**Project: South Battery Park City Resiliency Project:  
Pier A Plaza / Battery Site Work And Near  
Surface Isolation (“NSI”) Construction Services  
Request for Proposals (“RFP”)**

**Date: February 2, 2023**

**RE: Addendum #7  
# of Pages: 85**

L-301A.00

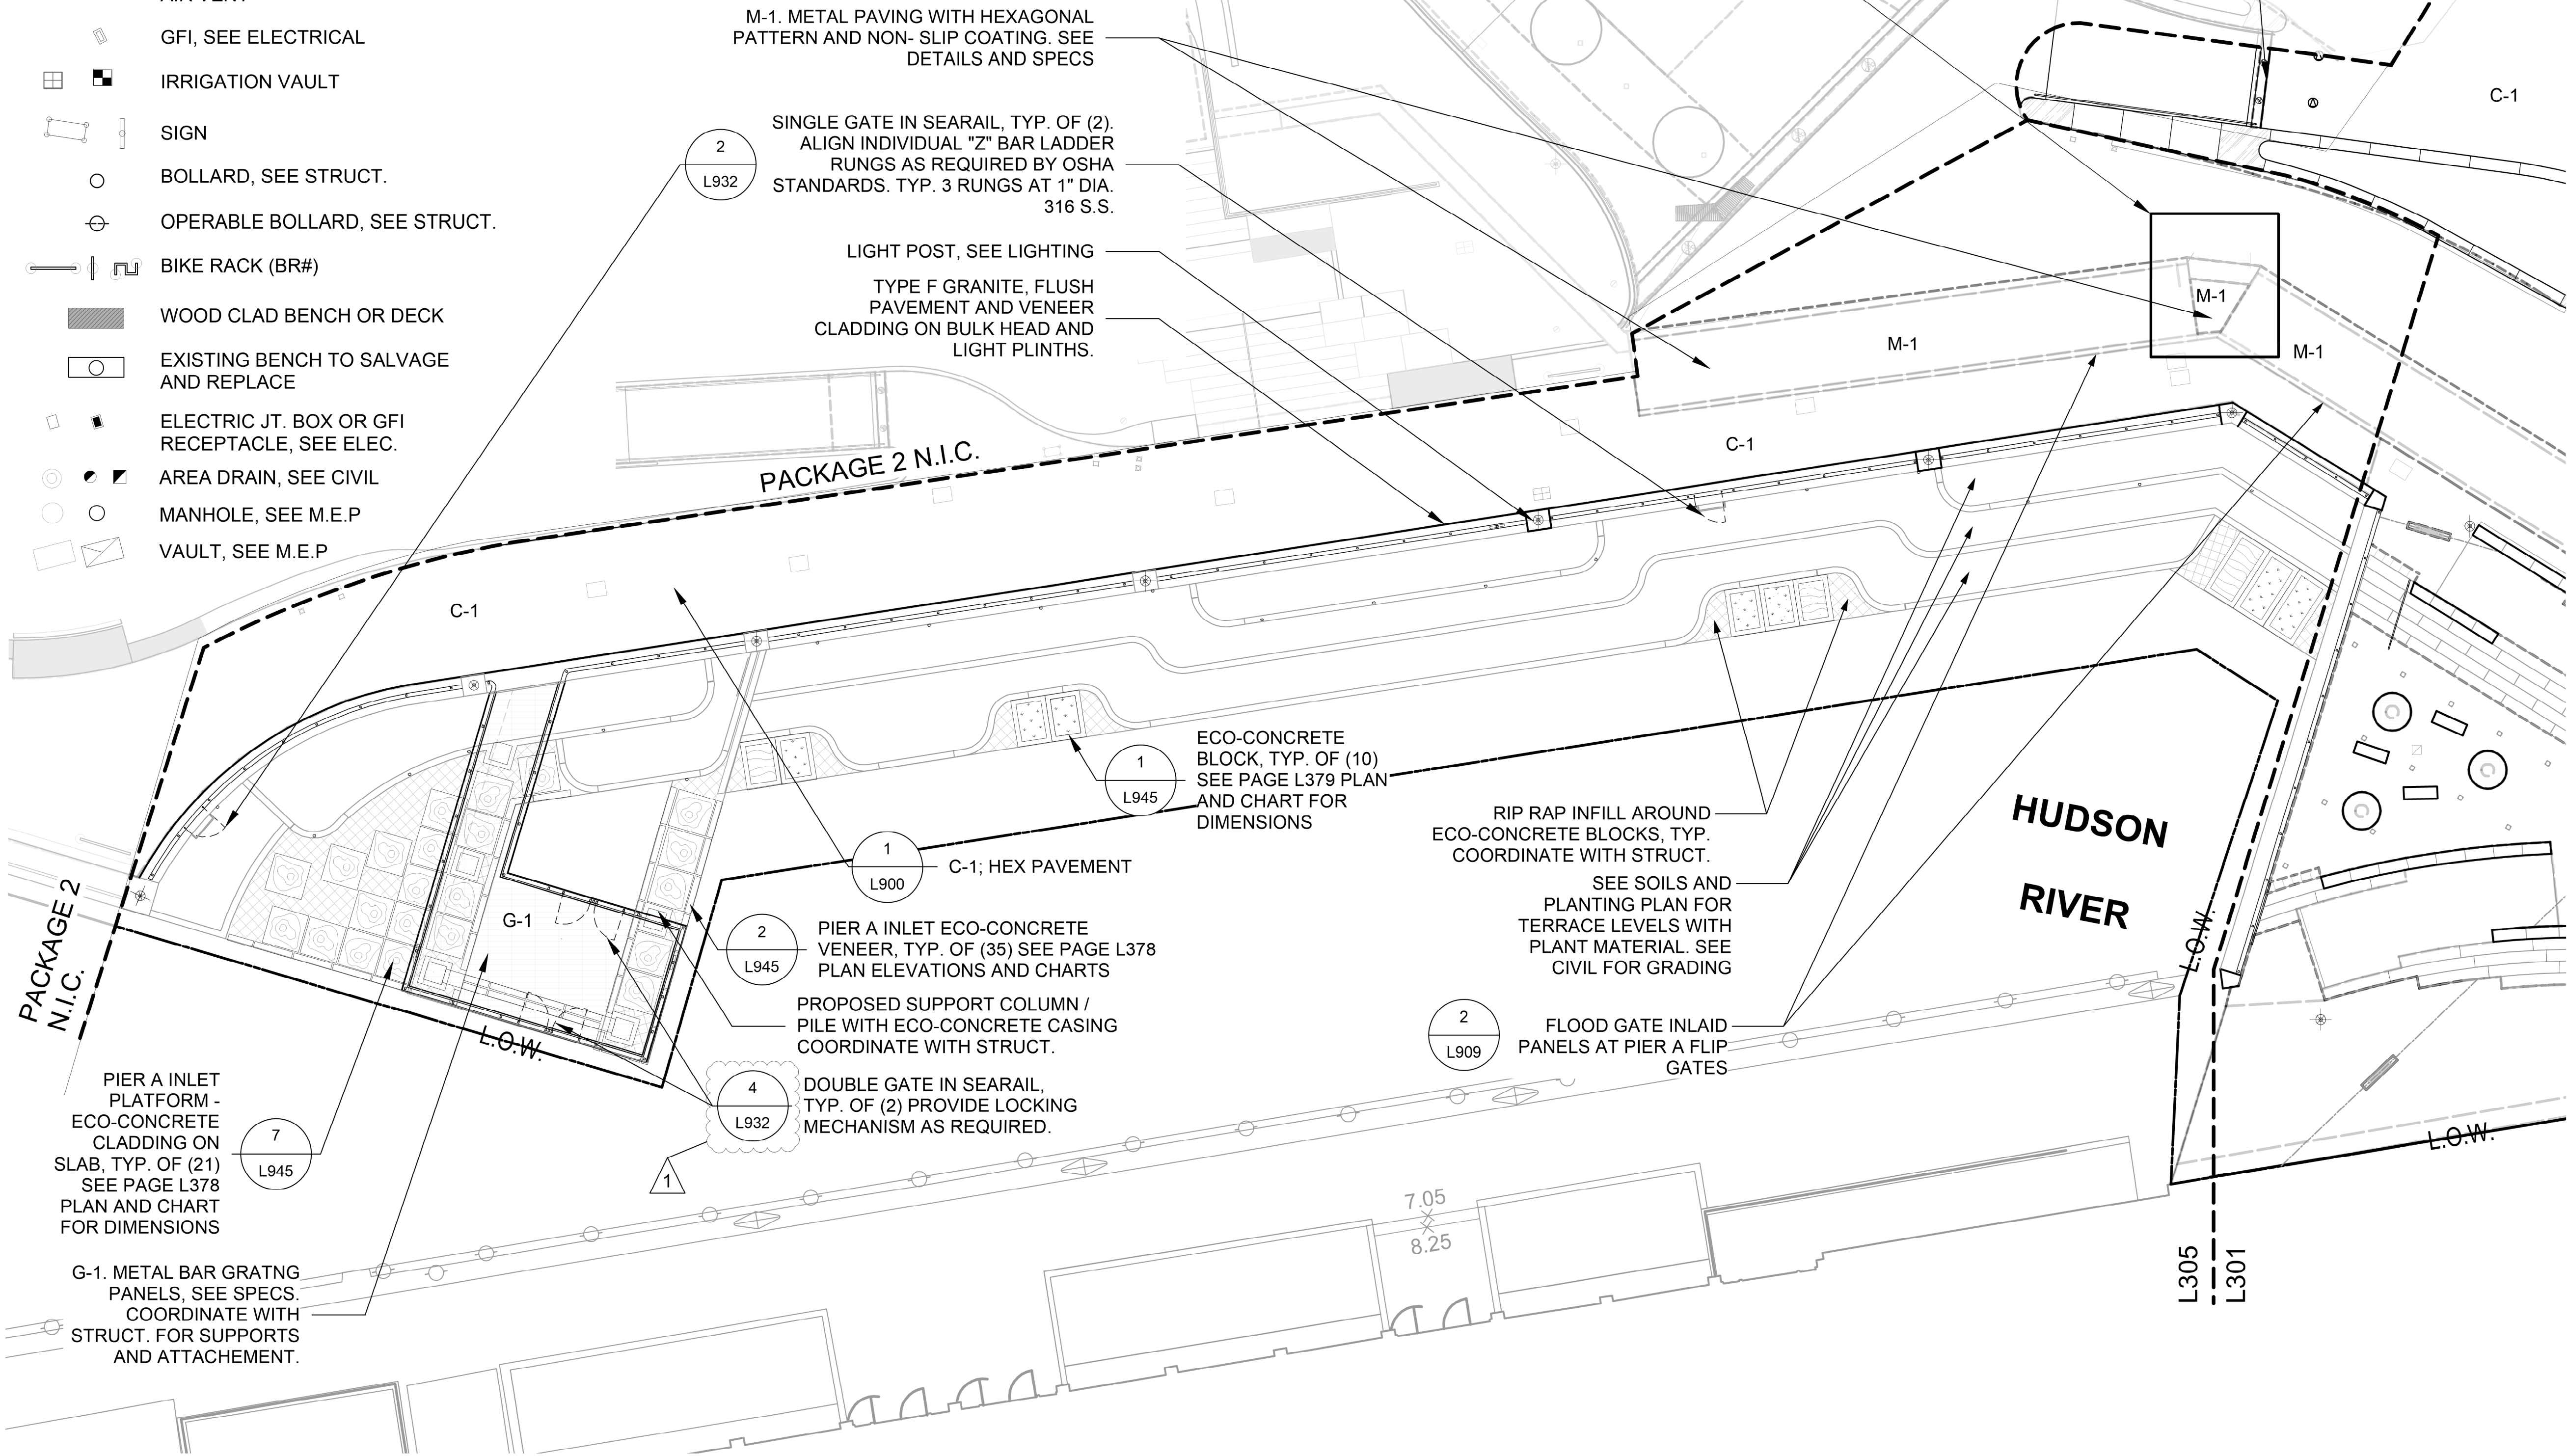
- 17) Reference Sheet L-301A.00: The 51’ LF Guardrail labeled as INLET AREA GUARDRAIL in the legend notes is called out as PLAZA AREA GUARDRAIL and refers to details: 2/L937 PLAZA AREA GUARDRAIL and All/L936. Please confirm if this 51’ LF guardrail is identified as the inlet area guardrail or the plaza area guardrail? Additionally, please clarify what specific detail and drawing we should refer to?

***The guardrail labeled as 2/L937 PLAZA AREA GUARDRAIL and ALL/L936 has been corrected to 1/L936 POST LAYOUT AT INLET AREA GUARDRAIL - ELEVATION. Additional callouts labeled as 3/L935 PIER A INLET GUARDRAIL and 2/L936 INLET AREA GUARDRAIL TYPICAL HANDRAIL AT STAIRS - ELEVATION will be added to Detail 1/L936 to better differentiate multiple detail interfaces. As noted in Section A – REVISIONS TO RFP (above), revised versions of Drawings L301A and L936 are both provided a part of Attachment #1.***

L-932.00

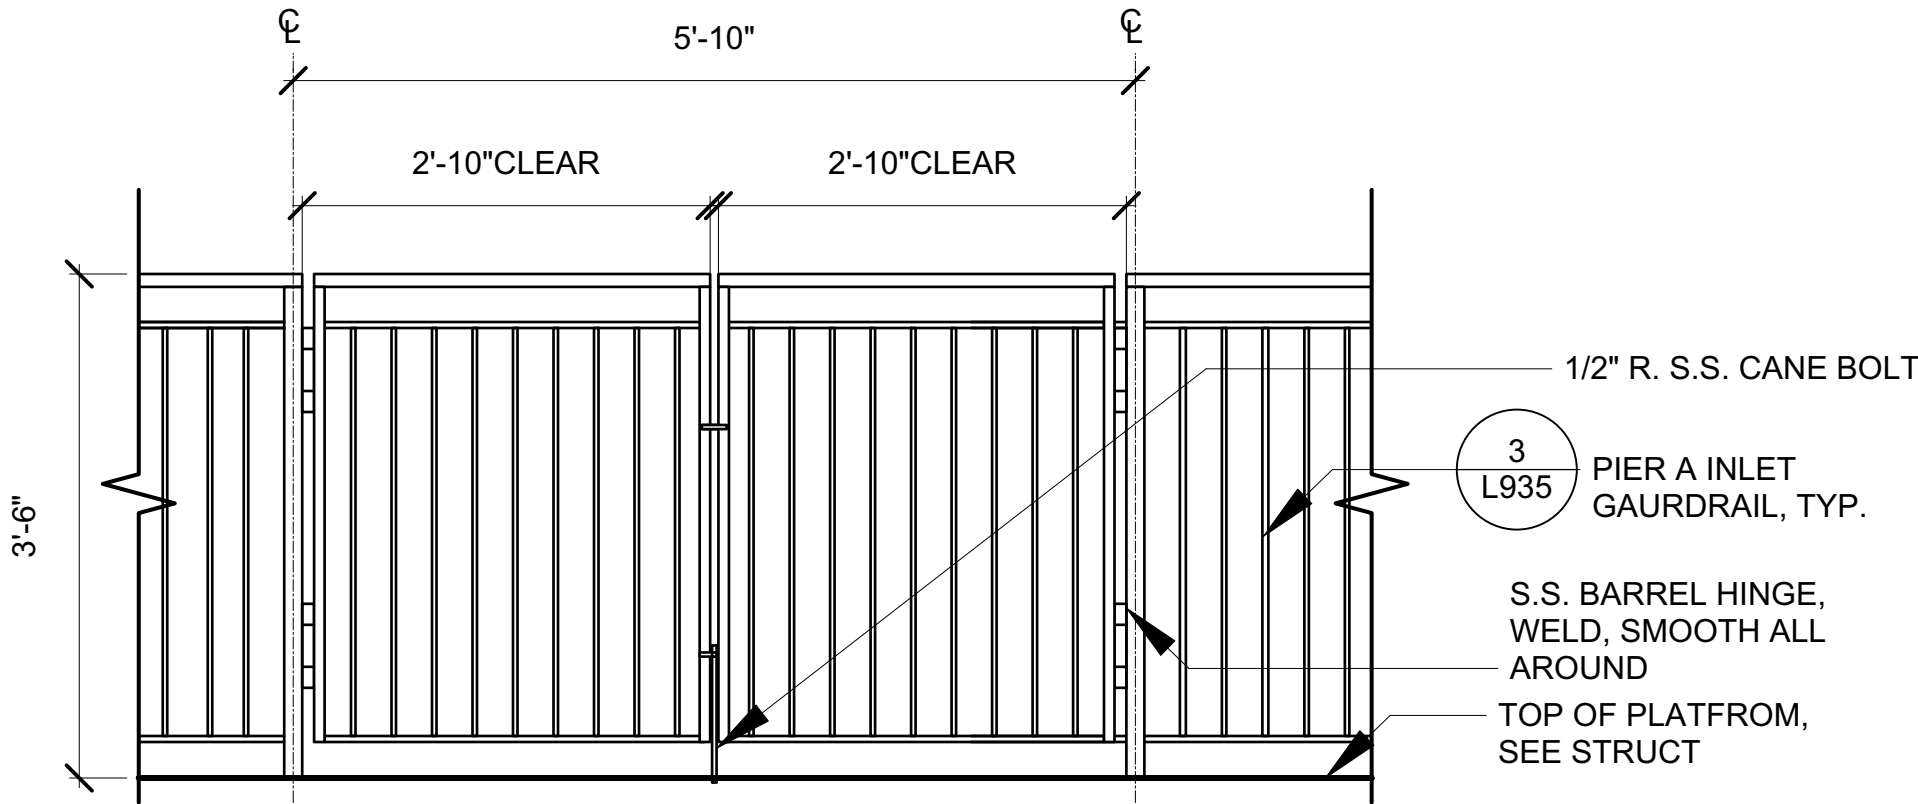
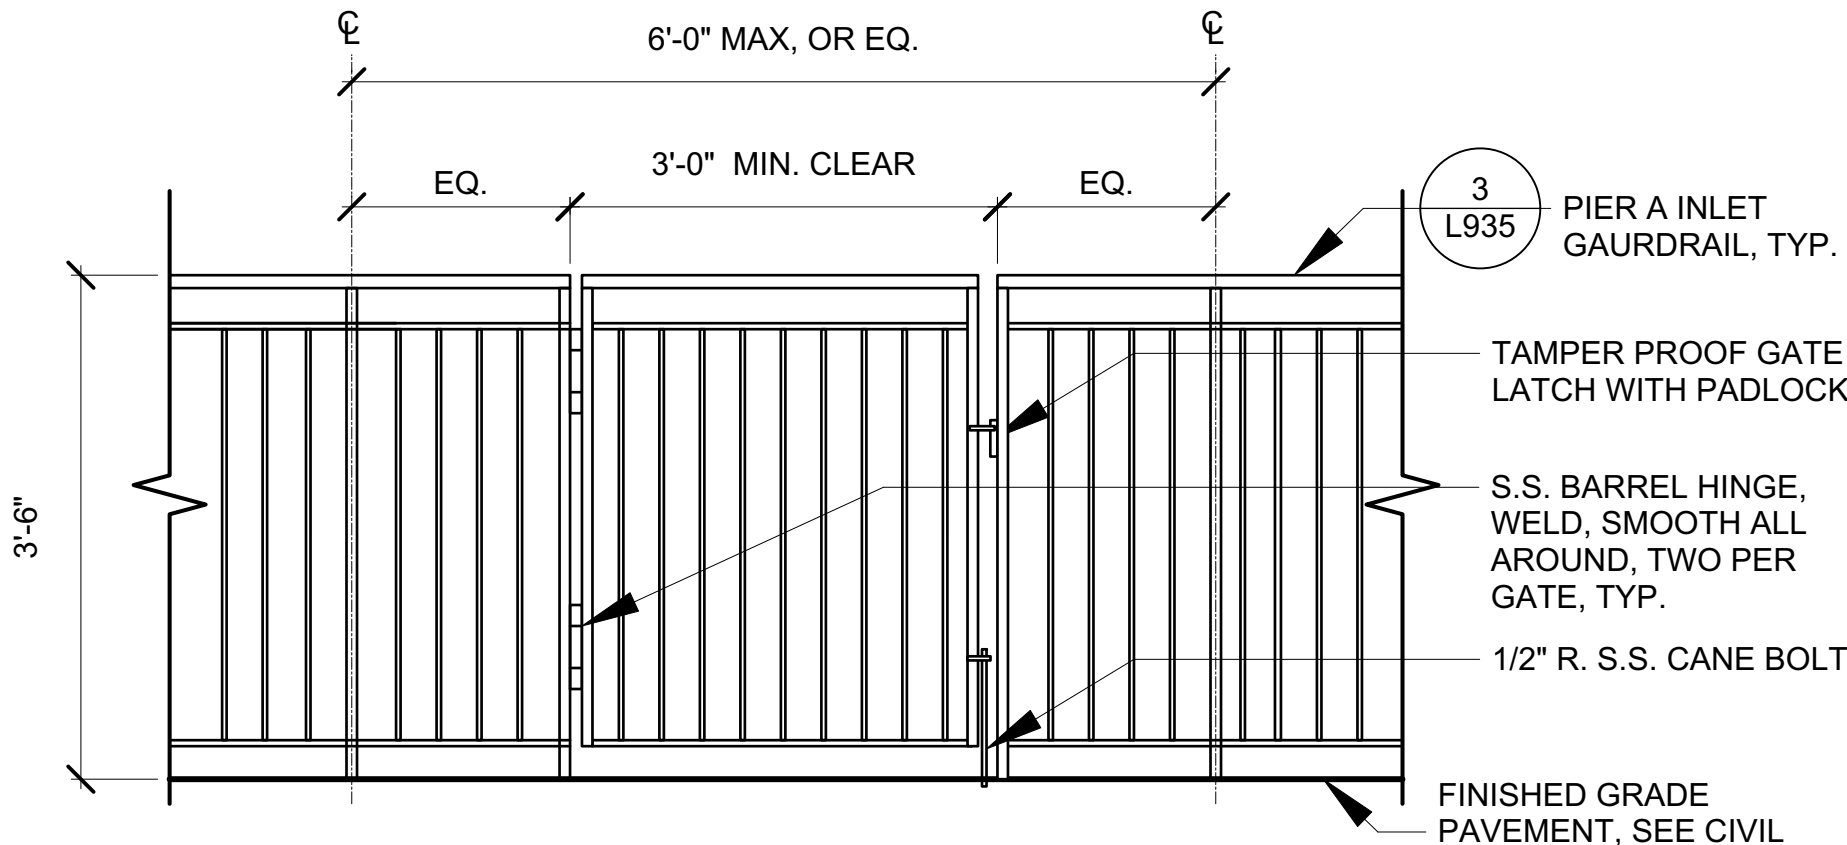
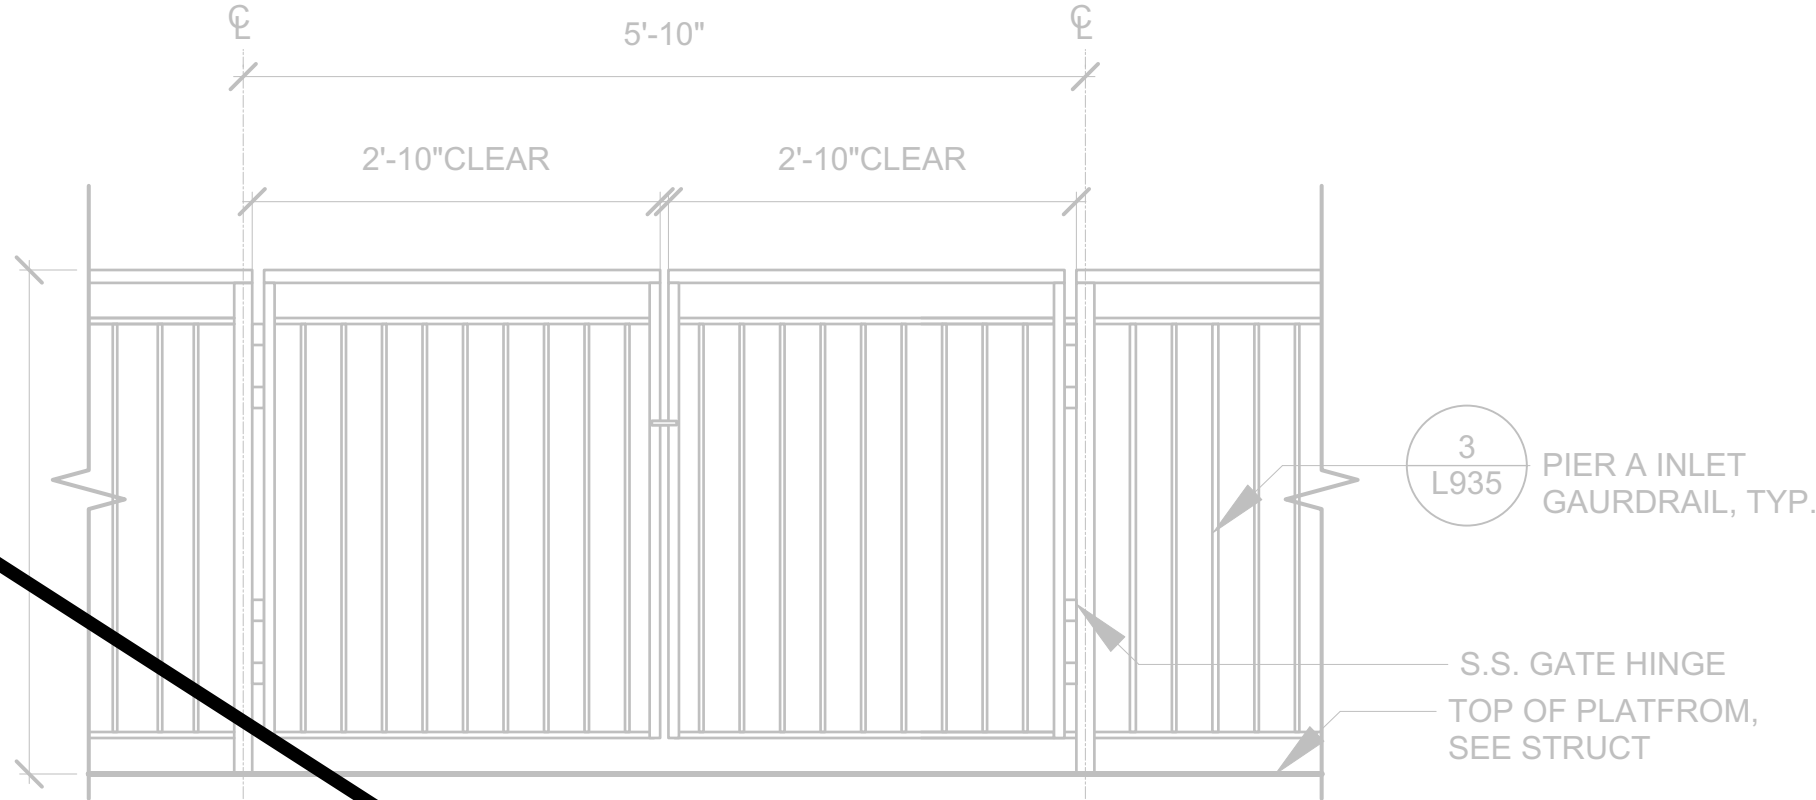
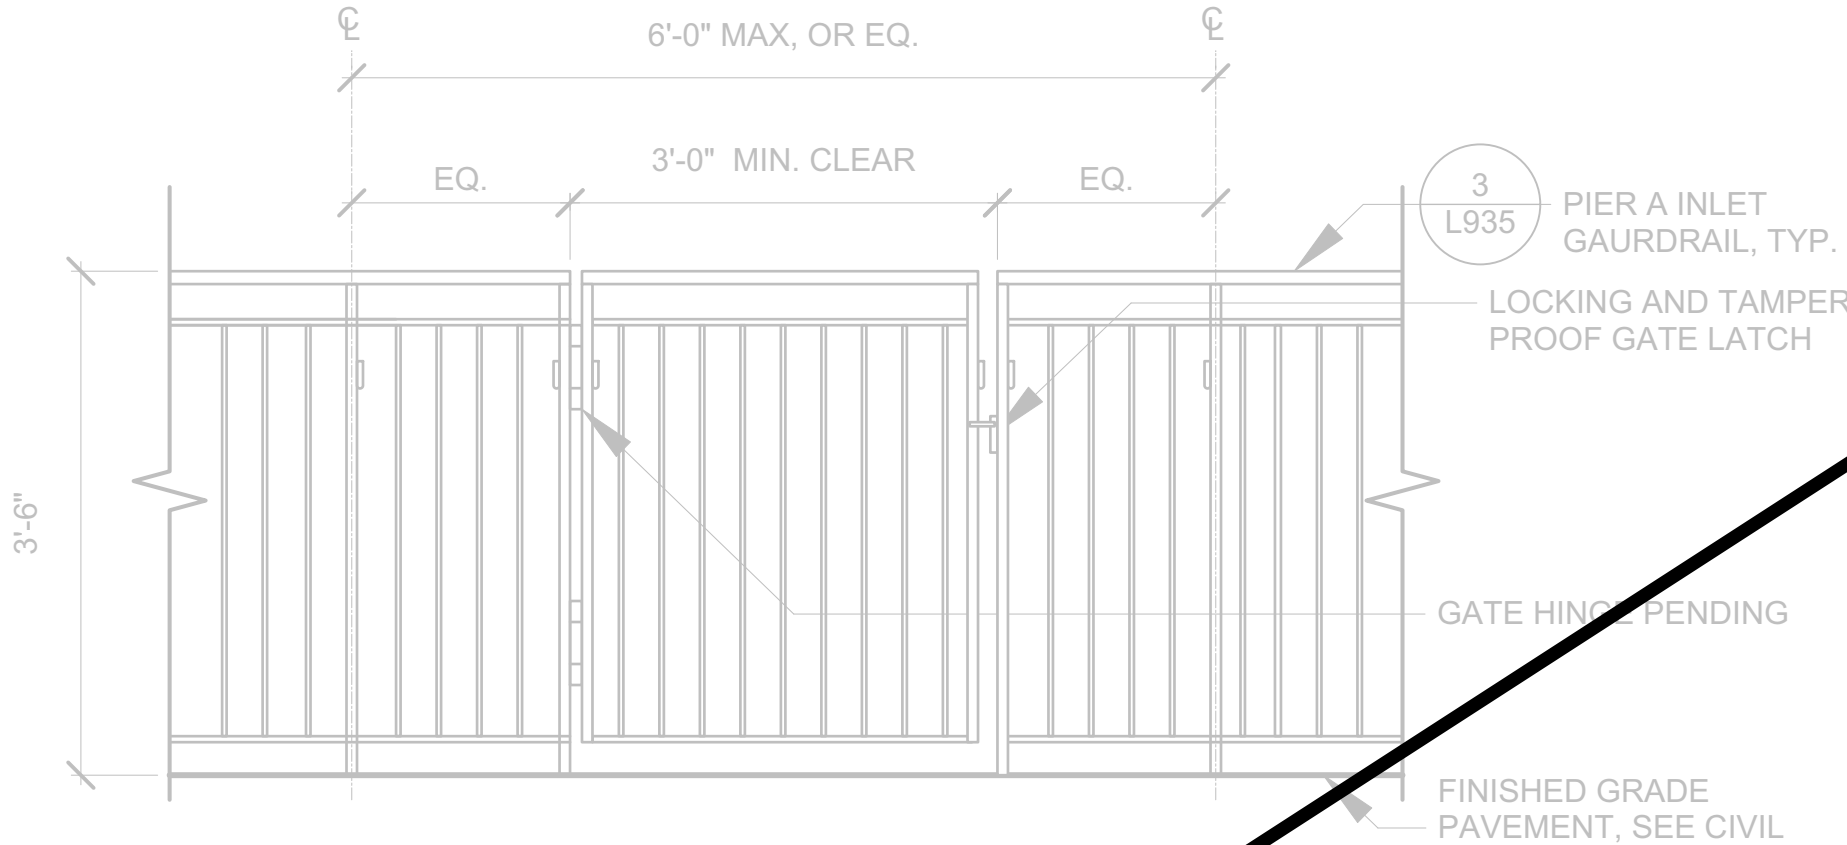
- 10) Sheet L-932.00 is included twice with slight differences in the Contract Drawings. Please clarify which one supersedes the other.  
***Drawing L932 was included twice in error. The correct version of Drawing L932 includes cane bolts on Detail 2/L932 and Detail 4/L932. As noted in Section A – REVISIONS TO RFP (above), both versions of Drawing L932 are provided as Attachment #1. Please note the duplicate page not to be used is crossed out and labeled PAGE NOT IN USE.***
